## SLG47525/28 Errata Note

This document contains the known errata for SLG47525/28 and the recommended workarounds.

Figure 1

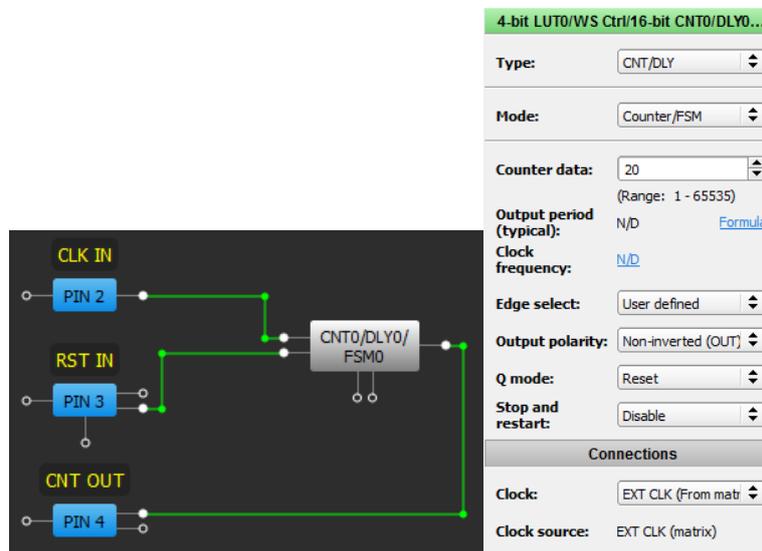
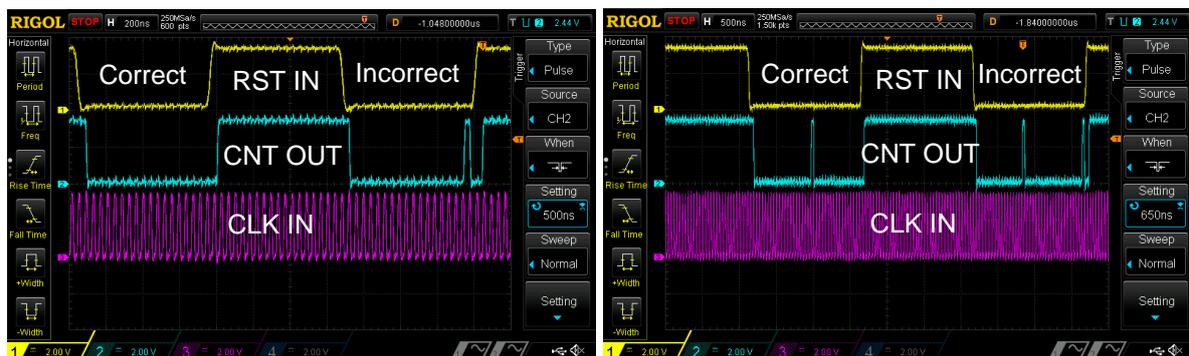
If the Counter Reset is asserted at the same time as a rising clock edge, it is possible that the Counter Data will be reset incorrectly and the counter output may appear faster than expected. This phenomenon appears more often as the clock frequency increases.

Figure 4

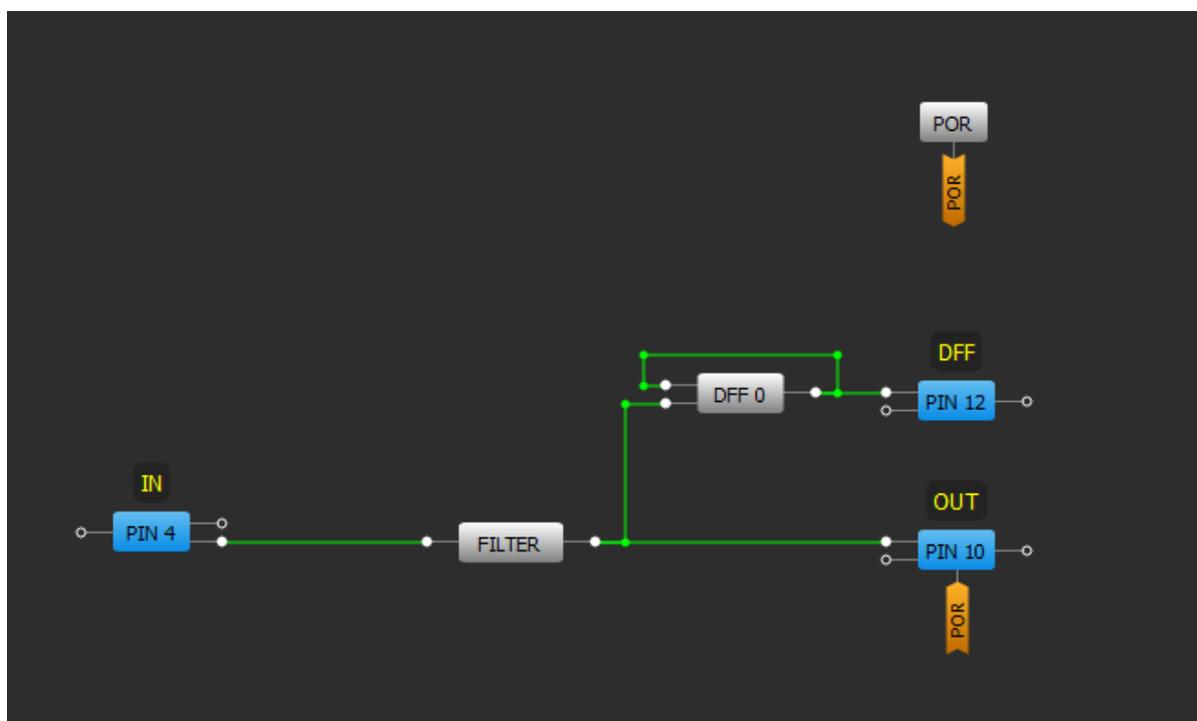
If clock type high frequency input comes in, the FILTER cell may not filter it out. There are several factors like input frequency, duty cycle, and LOW duration in such signal that may lead to its passing through FILTER block.

Currently there is no workaround for this issue. Filter block is good at filtering short spontaneous glitches. It is intended to be used in series connection before the delay cell to avoid its latching.

Figure 10. I<sup>2</sup>C Write of 16-Bit Counter Data Example

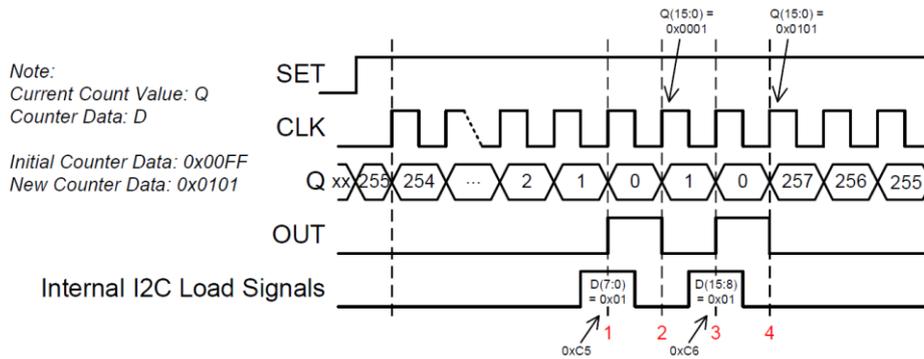
The timing diagram in [Figure 10](#) sets up a case where an improper output will be seen on the counter. In this example, the initial Counter Data value (D) is set up as 0x00FF. As you can see, the Current Count Value (Q) decrements from 255 down to 0 with rising edges on CLK. At time "1" denoted by a red number 1, an I<sup>2</sup>C command (not shown) has just been sent to the GreenPAK device to reconfigure the Counter Data value to 0x0101.

As previously mentioned, the 16-bit value is loaded from the I<sup>2</sup>C buffers to the Counter Data registers in 8-bit chunks. Right at time “1”, the LSB byte (0x01) is loaded into the Counter Data registers. This makes the Counter Data value temporarily equal to 0x0001. At time “2” between the internal I<sup>2</sup>C load signals, the counter receives a rising edge on its clock input. This causes the Current Count Value to underflow and to be loaded with the Counter Data value which is 0x0001. At time “3”, the MSB byte (0x01) is loaded into the Counter Data registers setting the Counter Data value to 0x0101. At time “4”, the Current Count Value underflows again and is set to the Counter Data value of 0x0101.

This behavior results in two output pulses on OUT when only one pulse is expected. Observing this behavior depends upon the asynchronous timing between the counter’s clock and an I<sup>2</sup>C write command to the Counter Data registers. For some applications, the extra pulse on OUT can be ignored and the counter will self-correct after underflowing, overflowing, or being SET/RESET through the GreenPAK connection matrix.

For applications where the application processor needs to read the Current Count Value while the counter is clocking, disable the “Stop and Restart Bit.” When this bit is disabled, the counter’s clock will not be gated internally which avoids the loss of count values during T<sub>stop</sub>. In order to guarantee the current count value after the I<sup>2</sup>C write to the Counter Data registers, the clock should be manually stopped for the I<sup>2</sup>C write or a SET/RESET command should be generated after the I<sup>2</sup>C write (Case 1).

I<sup>2</sup>C Write of Counter Data: accommodate for the double pulse described in Case 1.

Disable the counter’s clock during the I<sup>2</sup>C write.

Manually SET/RESET the counter after the I<sup>2</sup>C write is complete.

Disregard the first set of pulses on the counter output after the I<sup>2</sup>C write by waiting for one counter cycle to complete. This allows the counter’s DFF chain to be loaded with the new Counter Data value after the counter overflows/underflows.

Figure 12. Counter Behavior

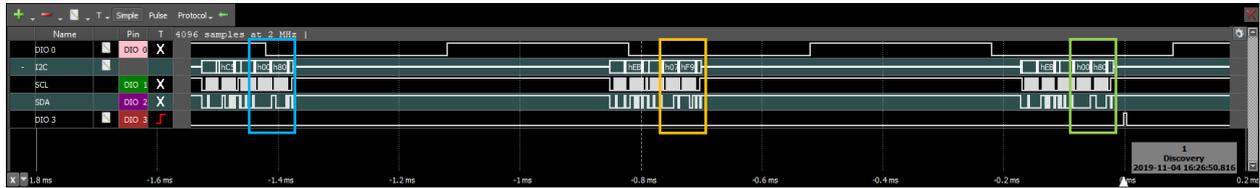
For the following condition, the Counter Data register contents are unexpectedly loaded into the counter’s DFF chain. This behavior occurs when there is a falling edge on the counter block’s clock input during the data return

portion of the I<sup>2</sup>C read of the Counter Data registers. Figure 12 shows this falling edge boxed in light blue followed by two I<sup>2</sup>C reads of the Current Count Value registers.

As you can see by the MCU data log below, the Current Count Value gradually increases from 0xF904 to 0xF907 but is unexpectedly reset to 0x8000. Please note that the colored HEX values in the MCU Log correspond to the boxed I<sup>2</sup>C read commands shown in the waveform above. As previously described, this reset occurs because there is a falling edge on the counter’s clock input while the GreenPAK device is responding to the I<sup>2</sup>C read request to 0xC5 and 0xC6 (note that 0xC5/0xC6 are the Counter Data registers and 0xEB/0xEC are the Current Count Value registers for CNT0).

The reason that the counter is not set to 0x8000 on the I<sup>2</sup>C read immediately following the Counter Data query is because the counter requires two rising edges on its clock input to load the data from the Counter Data registers into the DFF chain. Note that all rising edges during T<sub>stop</sub> will be gated internally by the “Stop and Restart” feature.

For systems that require I<sup>2</sup>C write access to the Counter Data registers while the counter is clocking, enable the “Stop and Restart Bit” (Case 2).

I<sup>2</sup>C Read of Counter Data: avoid reading Counter Data via I<sup>2</sup>C while the counter is being clocked.

Within the MCU, we recommend saving the Counter Data register configuration as a software variable so that the Counter Data register does not need to be read during counter operation.

Figure 13

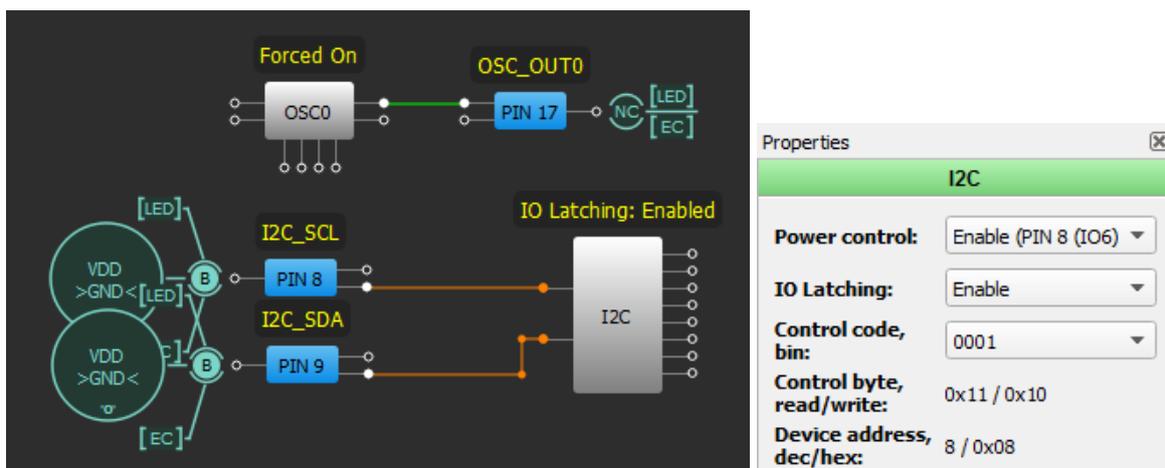
The GreenPAK device does not check for a matching I<sup>2</sup>C Slave address condition before triggering ‘IO Latching’. A Start bit on the I<sup>2</sup>C bus will trigger IO Latching. A Start bit is when I2C\_SDA goes low first followed by I2C\_SCL going low after.

In the example in [Figure 13](#), we will be monitoring the OSC output, which is measured by a scope on Channel 3 via PIN17 (“OSC\_OUT0”). The I<sup>2</sup>C bus will be forced low to create a START bit.

By toggling I2C\_SDA low and then I2C\_SCL low, the GreenPAK registers this as a start bit and latches all General Purpose Outputs such as PIN#17 (“OSC\_OUT0”). In Figure 14, notice that PIN#17 (OSC\_OUT0) stops toggling.

Disable IO Latching in programmed OTP. This register is I<sup>2</sup>C-write locked during normal operation and therefore should be disabled in configuration file.

Do not share I<sup>2</sup>C bus with other devices and make sure the I<sup>2</sup>C bus is not powered down while the GreenPAK is still powered through V<sub>DD</sub>.

If the above cannot be satisfied, then consider using the SLG4658x devices, where this errata has been fixed.

Figure 15. Test Design

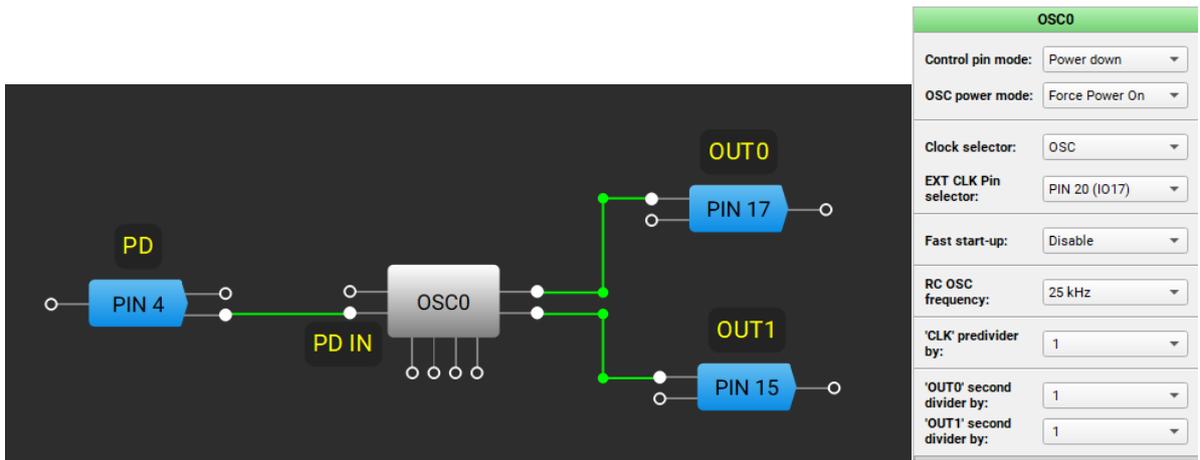
When a short pulse is applied to the PWR DOWN input, the oscillator exhibits a long start-up time.

When a short pulse of less than ~40 ns is applied to the PWR DOWN input.

Figure 16. 25 kHz OSC Long Start-Up

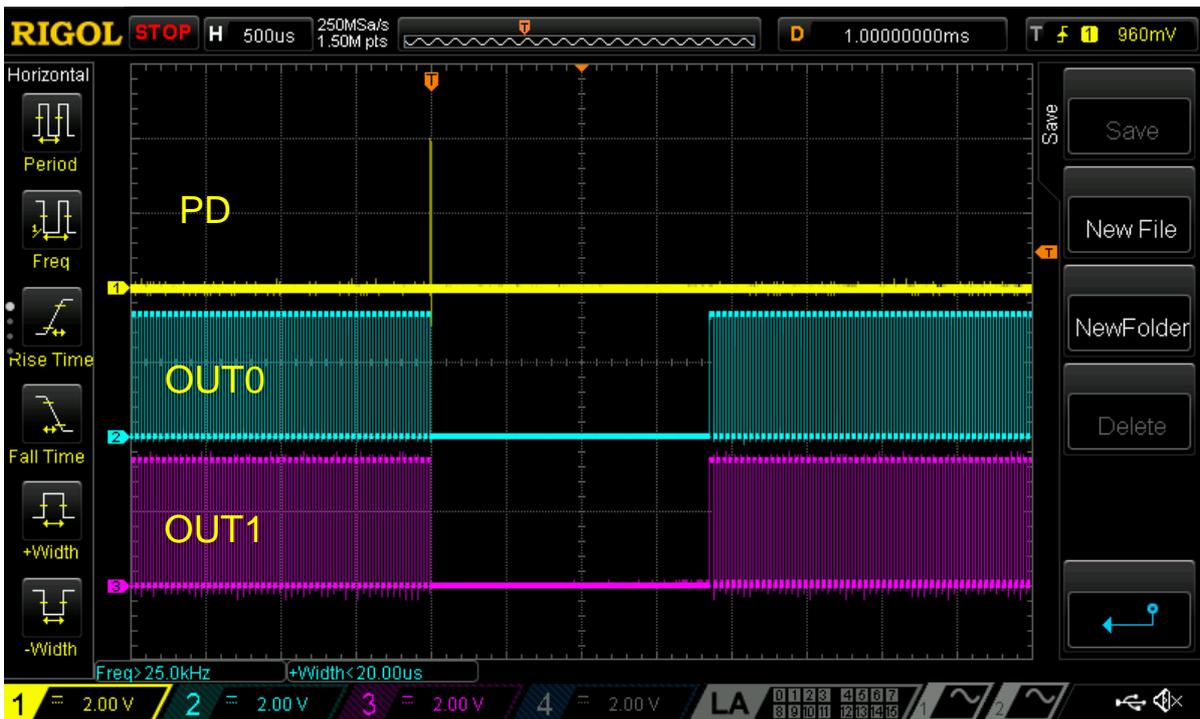
If a pulse with a duration of less than ~40 ns is applied to the PWR DOWN input of the oscillator, the oscillator outputs remain stuck for milliseconds, as shown in Figure 16 and Figure 17. The issue is observed for all available oscillators.
